| DA14592 Standard Module |                   |
| Design Name             | DA1459x_module    |
| Ref. Number             | 469-17-D          |
| Version                 | D                 |

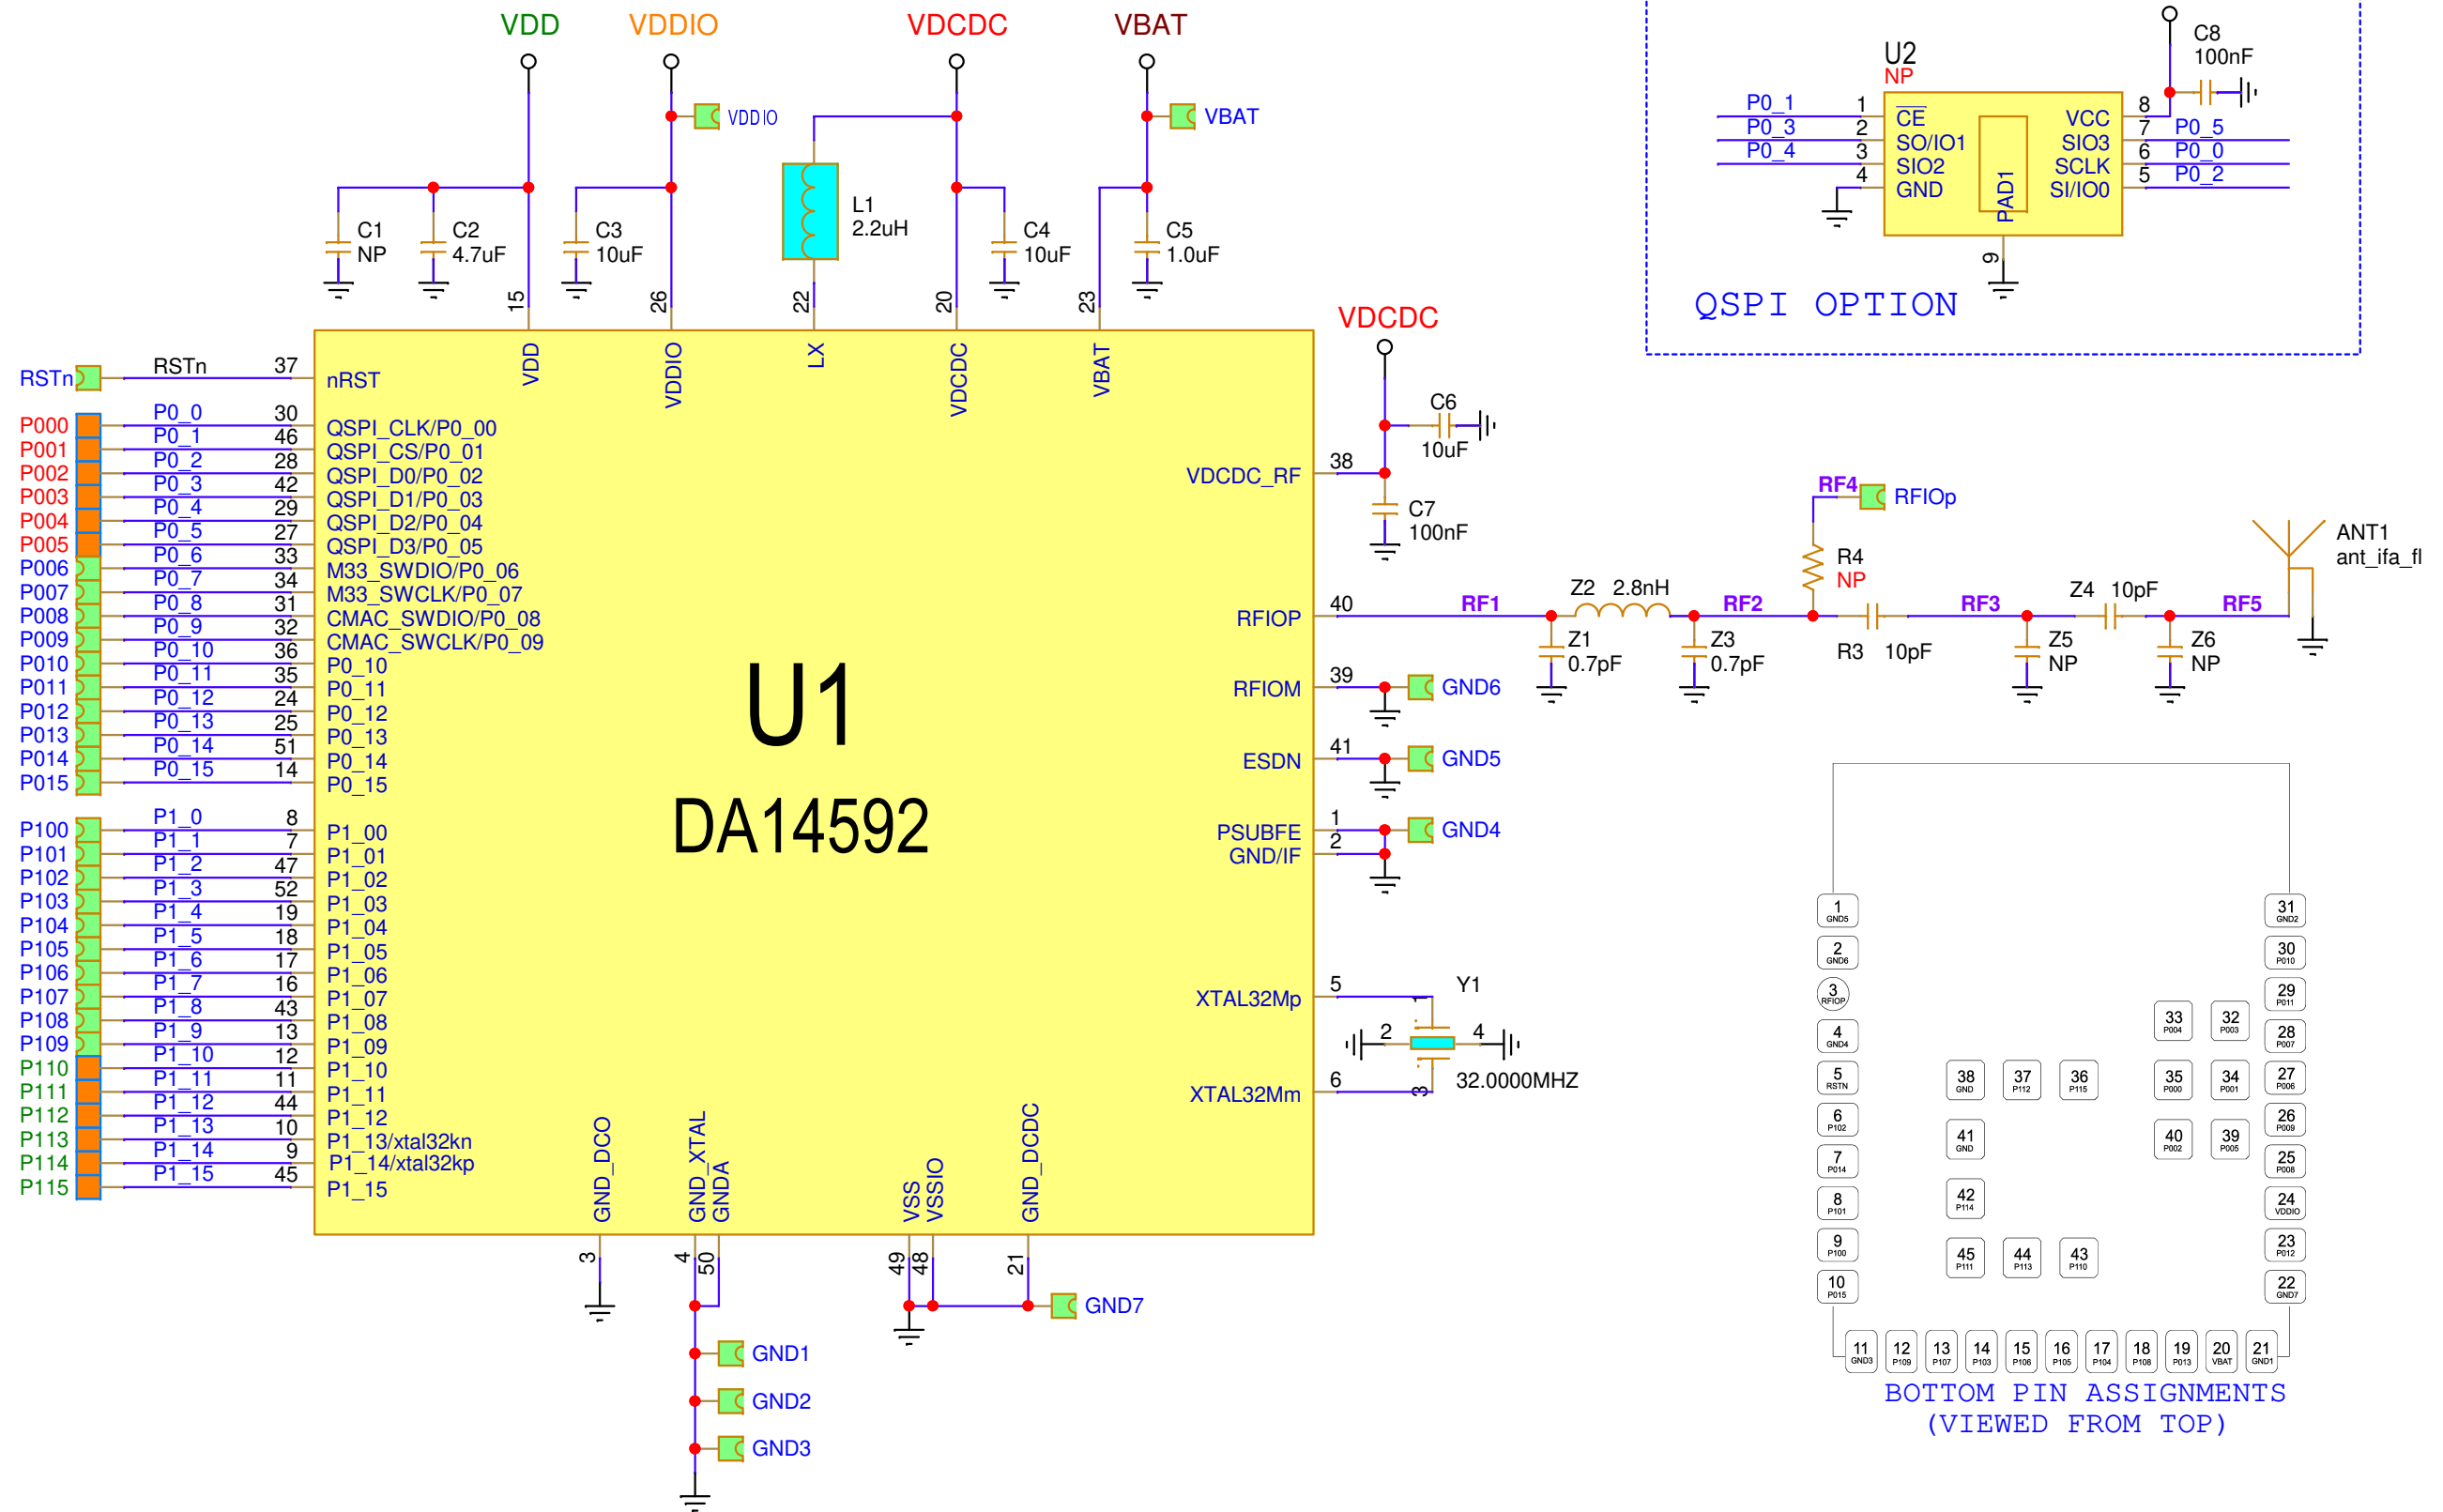
| History Table |             |                                                                                                                                                                                                          |
|---------------|-------------|----------------------------------------------------------------------------------------------------------------------------------------------------------------------------------------------------------|
| A             | 27/Jun/2023 | Changed L1 part number to LSANB2016KKT2R2M                                                                                                                                                               |
| A2            | 13/Jul/2023 | Corrected Y1 Manufacturer_Part_Number to XRCGB32M000F1SBAR0<br>Released to manufacturing                                                                                                                 |
| B             | 05/Sep/2023 | Modified the printed antenna in layout editor                                                                                                                                                            |
| C             | 05/Oct/2023 | Changed Z1,Z3 part number to GJM0335C1HR70WB01D<br>Changed Z2 part number to LQP03TG2N8B02D<br>Changed R3,Z4 part number to GRM0335C1H100JA01J<br>Modified mask openings for the shield in layout editor |
| D             | 16/Oct/2023 | Changed C2 part number to GRM155R60J475ME47 (4.7uF/0402)<br>Changed C3, C4, C6 part number to GRM155R60J106ME05D                                                                                         |
